REGIONAL REVIEW NOTICE

ARC REVIEW CODE: R1603291

Name of Proposal: Dunwoody Crown Towers

SUBJECT: **Transportation Division Review of DRI # 2567**

1 SITE PLAN - DRI
1" = 150'-0"

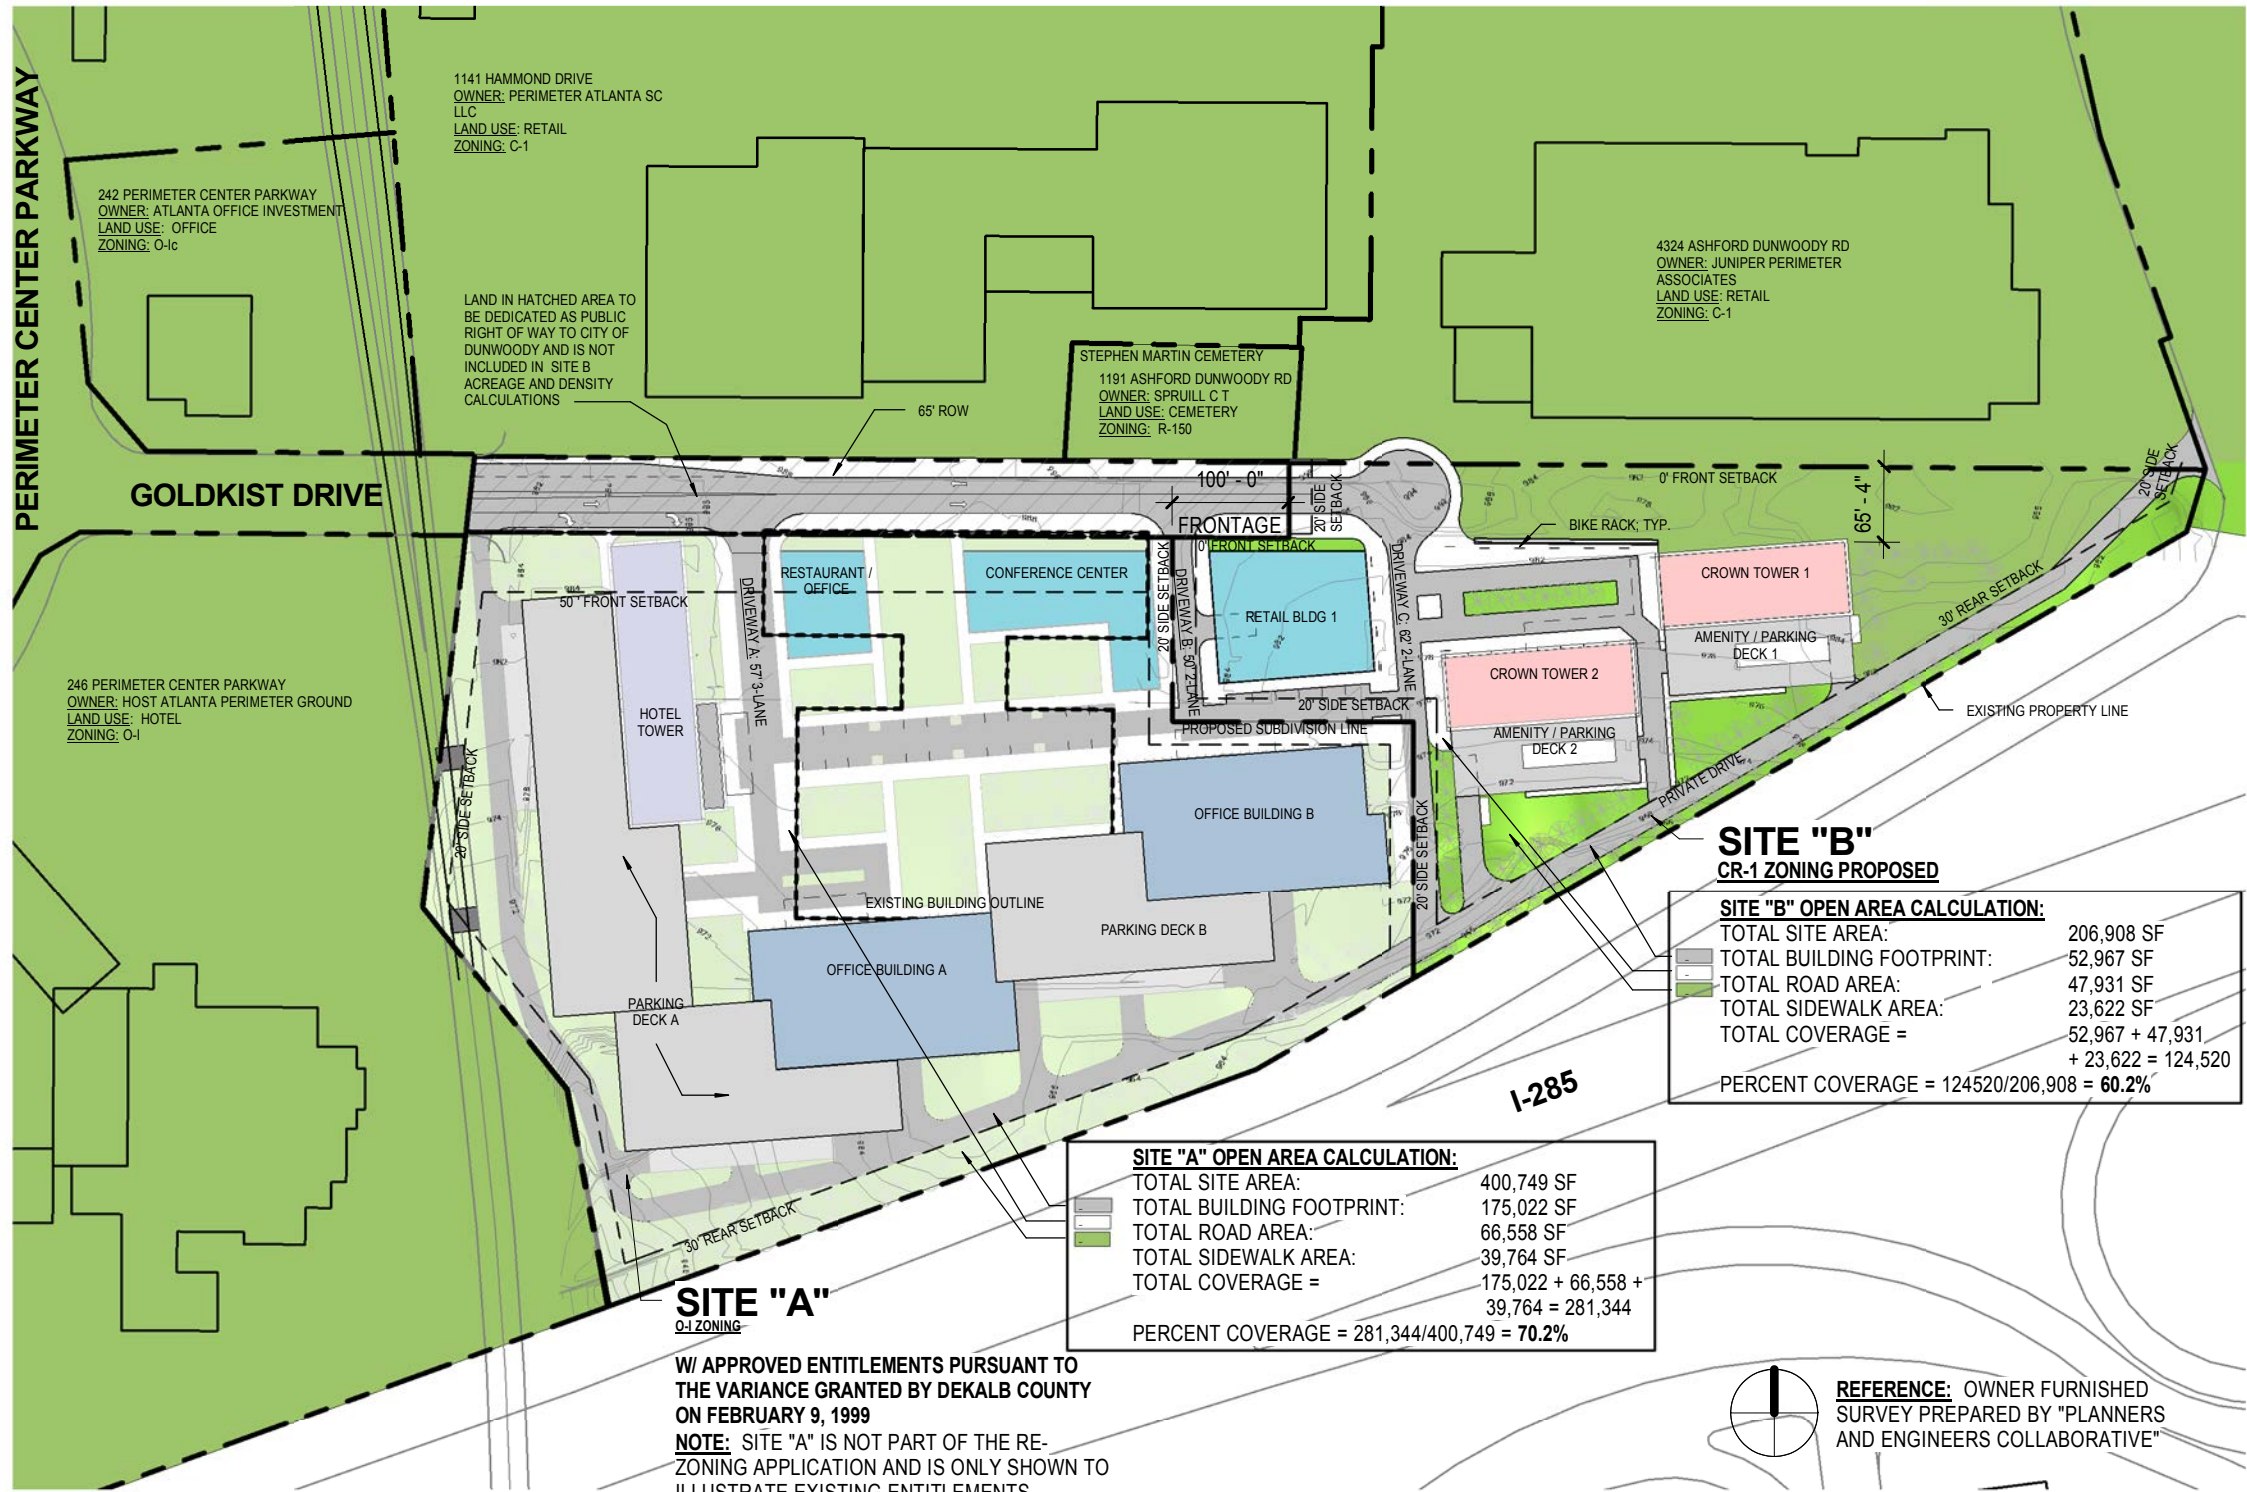
Off-street loading for site “B” is identified on the site plan, but loading spaces for the other buildings was not identified. Adequate off-street loading spaces should be provided for all proposed buildings and should meet the zoning and other relevant ordinances from the City of Dunwoody.
